PROJECT:	carwash development
CLIENT:	colgrave holdings pty ltd
ADDRESS:	216-218 westbury road, prospect
<small>CONTRACTORS USING THIS DRAWING MUST VERIFY ALL INFORMATION HEREIN BEFORE COMMENCING ANY WORKS OR PREPARING SHOP DRAWINGS AND THE USE OF THIS PLAN IS AN ACKNOWLEDGMENT THAT ALL NECESSARY CHECKS HAVE BEEN CARRIED OUT PRIOR ANY COMMENCEMENT OF WORKS. ALL EXISTING CONDITIONS INCLUDING BUT NOT LIMITED TO SITE DETAILS, LEVELS, EXISTING BUILDING STRUCTURES MUST BE CONFIRMED ON SITE FOR ACCURACY. THIS OFFICE MUST BE NOTIFIED IF ANY DISCREPANCIES ARE NOTED. THIS DRAWING IS TO BE USED ONLY FOR THE REASON FOR WHICH IT WAS ISSUED. THIS DRAWING REMAINS THE PROPERTY OF MCL BUILDING DESIGN. THIS DRAWING IS PROTECTED BY COPYRIGHT LAWS AND MUST NOT BE AMENDED WITHOUT OBTAINING WRITTEN CONSENT.</small>

Re: Request for Further Information

216-218 Westbury Road – Carwash Proposal

Date:	16/12/15
Name:	Mr Barry Colgrave – Colgrave Holdings
Project Description:	Carwash Development Proposal
Project Address:	216-218 Westbury Road, Prospect

DRAWING TITLE: site plan
DRAWING No: tp2
REVISION No: b

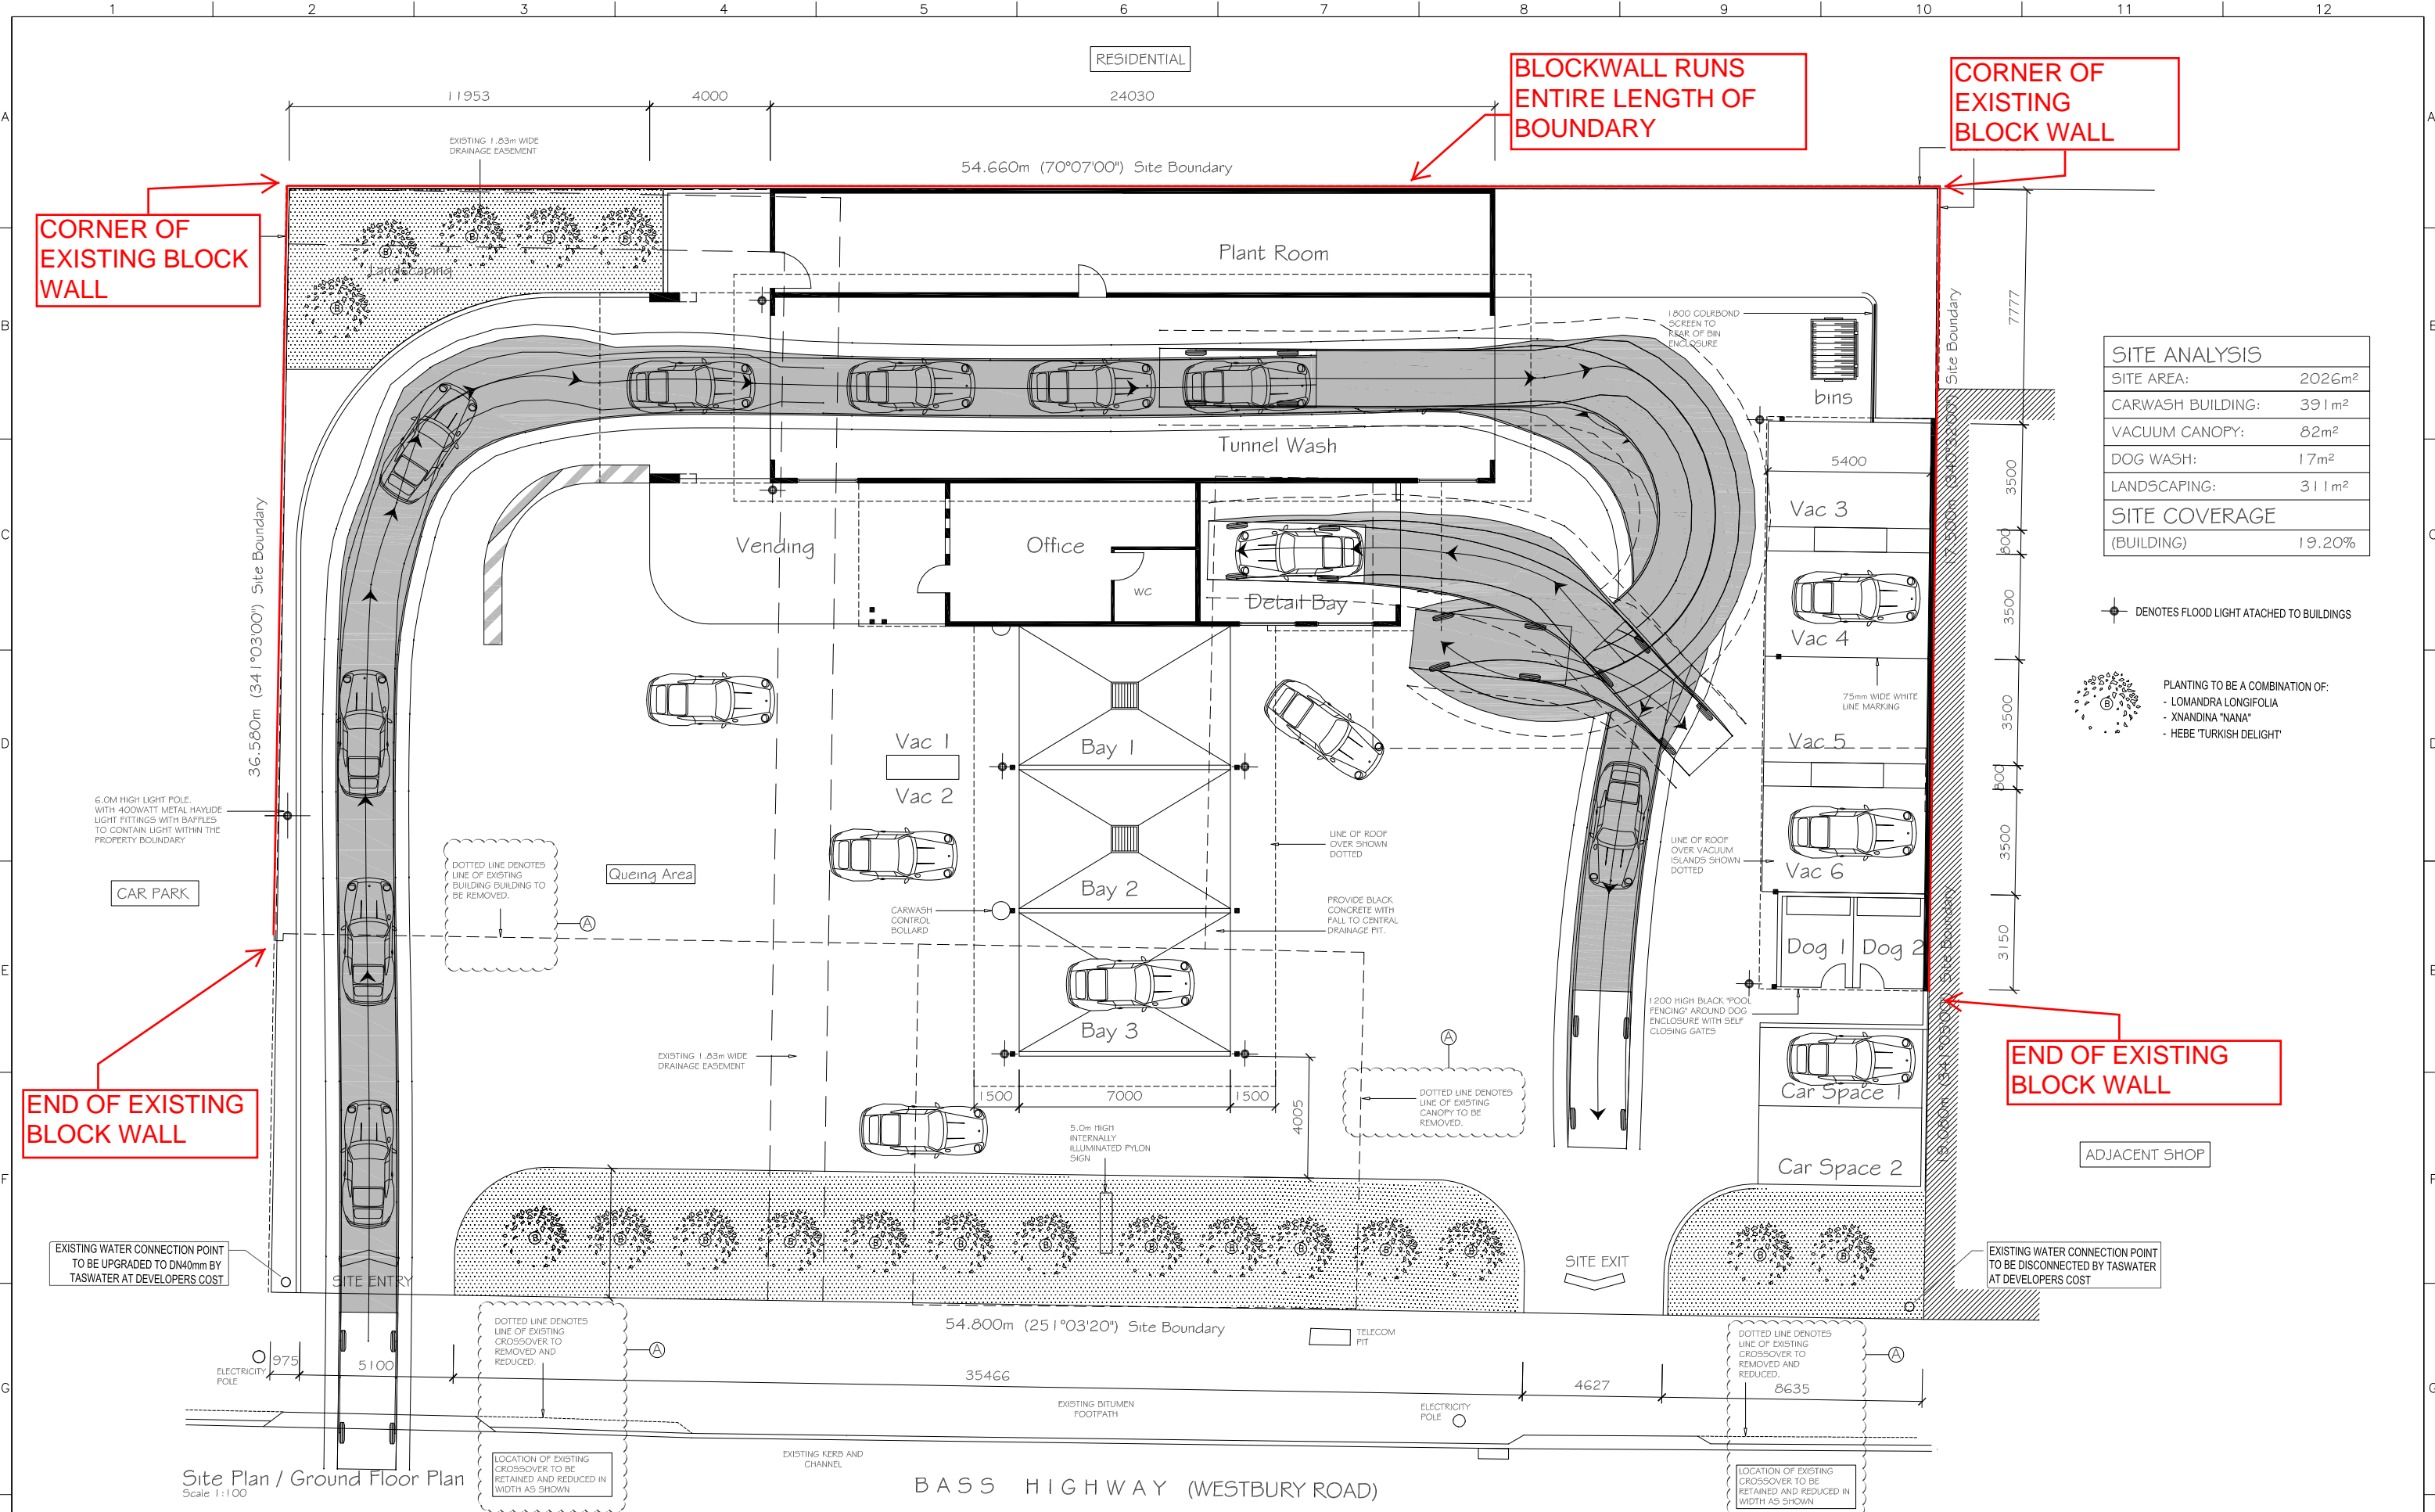
Please provide a detailed landscaping plan showing the location of plants, the species to be used and the expected height at maturity. **As per attached supplied plan.**

EQ BLOWER - SOUND TEST
SCALE: AS SHOWN

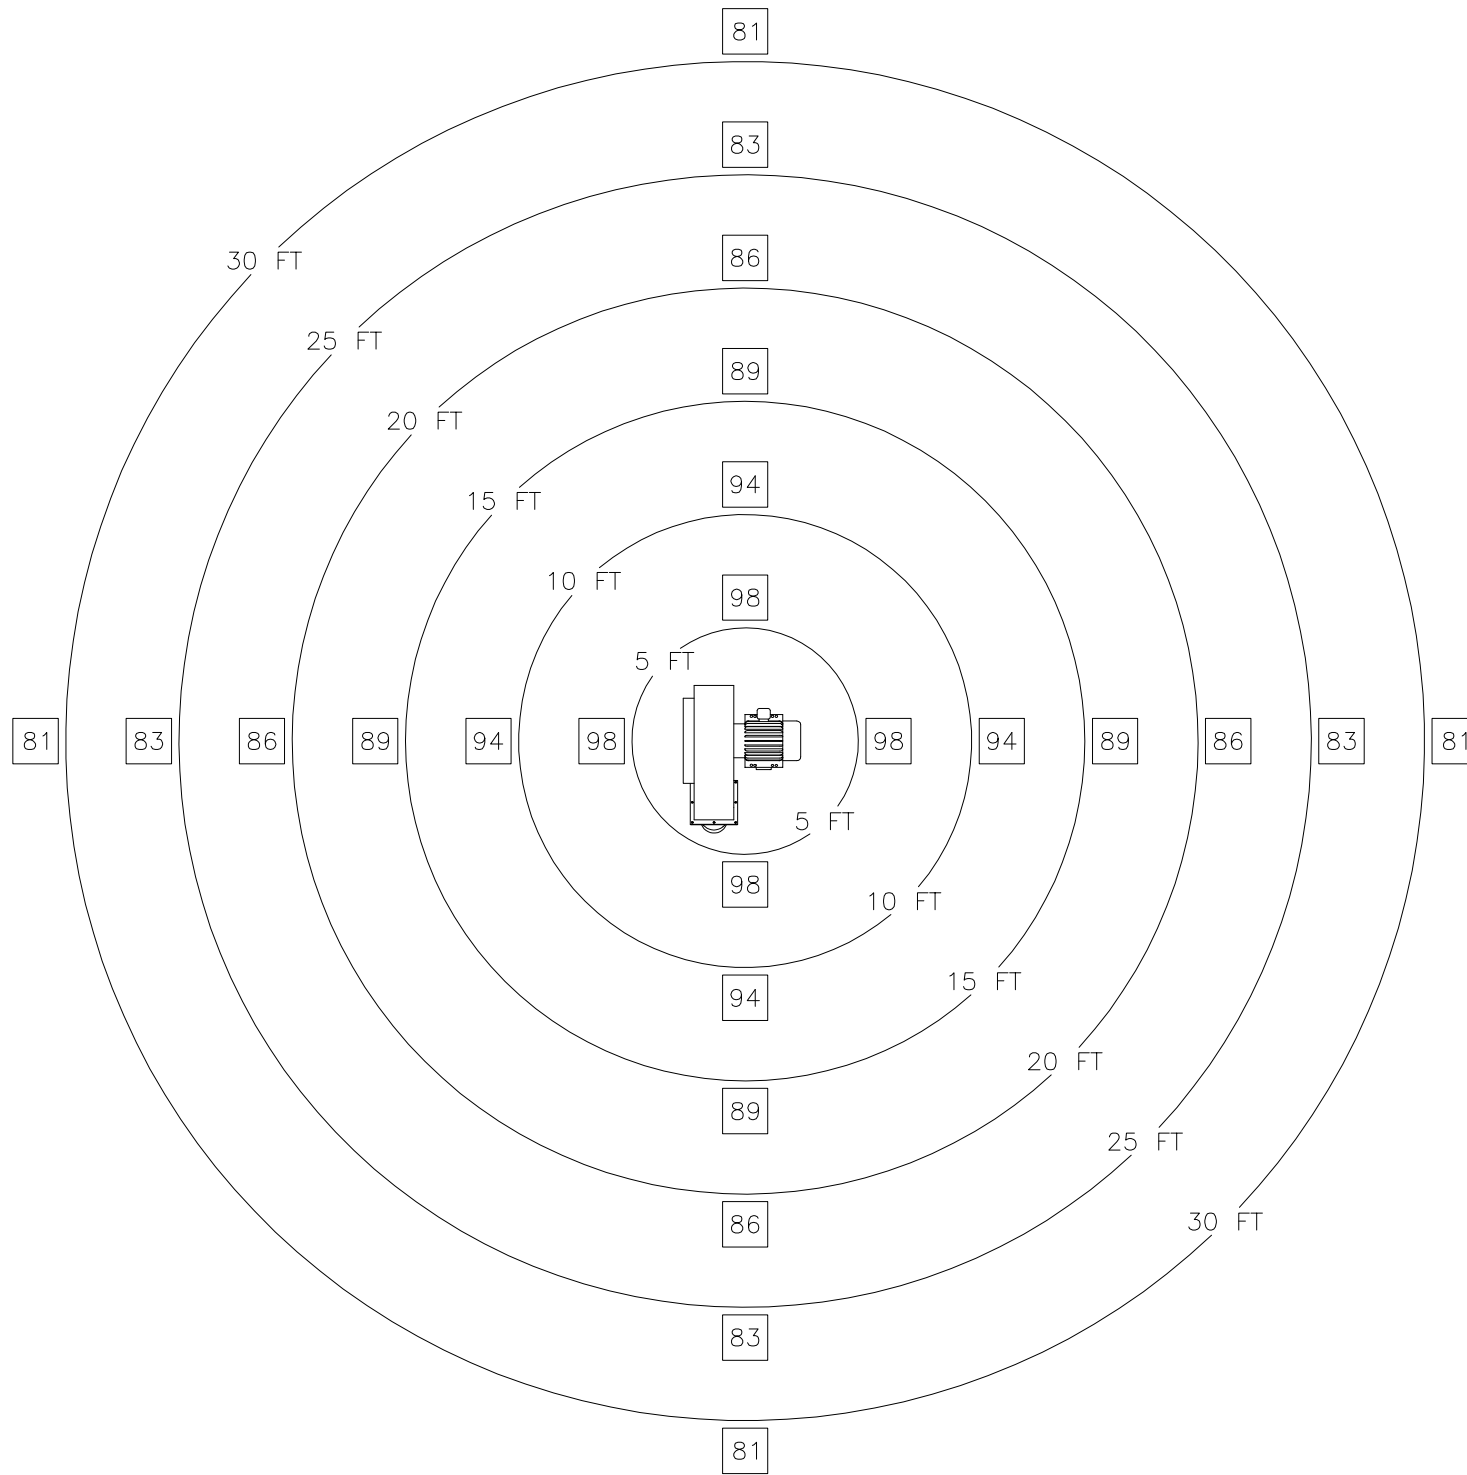
Please provide information regarding any potential noise or other nuisance from equipment associated with the proposed car wash (e.g. compressor, heat pump, alarms, public address system, overspray from wash bays etc.) or activity that may potentially cause an environmental nuisance and detail how the noise/nuisances may be controlled to prevent emissions leaving the property.

With respect to noise, a report from an acoustic engineer would satisfy this request however alternative solutions may be considered provided the information provided satisfies this request.

Refer to the attached documents from equipment supplier re: loudest equipment noise levels.

Attached is acoustic information I have on the dryers of the tunnel equipment. This is the noisiest part of the car wash. Bear in mind that this will only be operating during attended hours as it requires an attendant to operate the tunnel. My estimate is that this will be from 7AM to 7PM.
